RE: Raging Bull-Devon - Trionyx Release Remedy MODIFICATION OF APPROVED PLAN Tuesday, March 7, 2017 2:13:01 PM Subject:

Subject: Raging Bull-Devon - Trionyx Release Remedy

To: Oberding, Tomas, EMNRD <Tomas. Oberding@state.nm.us>; Billings, Bradford, EMNRD <Bradford, Billings@state.nm.us>; Lynch, Kristen, EMNRD <Kristen.Lynch@state.nm.us>; 'Tucker, Shelly' <stucker@blm.gov> Cc: Fulks, Brett'<Brett-Fulks@dvn.com>; 'FERNANDO IBARRA' <fernando.ibarra@ragingbulloilfield.com>; 'Martin Lebrun' <martin.lebrun@ragingbulloilfield.com>; mike@rthicksconsult.com; jctrucking@pvtnetworks.net
Subject: Raging Bull-Devon - Trionyx Pilot Test

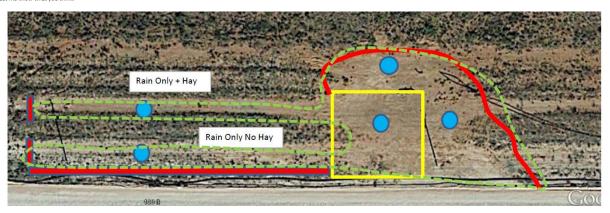
- 1. Spill footprint is outlined in green dashed line it is approximate
- The yellow 50 foot by 50 foot square is isolated from storm water run-on. This is the plot that will get fresh water from a pipeline or truck. We should have 1 deep sample in this area.
- 3. The area of Rain Only + Hay is bounded on the north and south by ridges created by pipelines. The reinforced berms to the east and west of this area isolate it from storm water run-on. We have one deep sample location in this part of the pilot study.

4. The south-western "leg" of the release footprint will not have hay tilled in. We will isolate this area from storm water run-on. One deep sample is planned here

5. The eastern portion of the spill footprint will receive storm water run-on. Two deep sampling points are planned for this area.
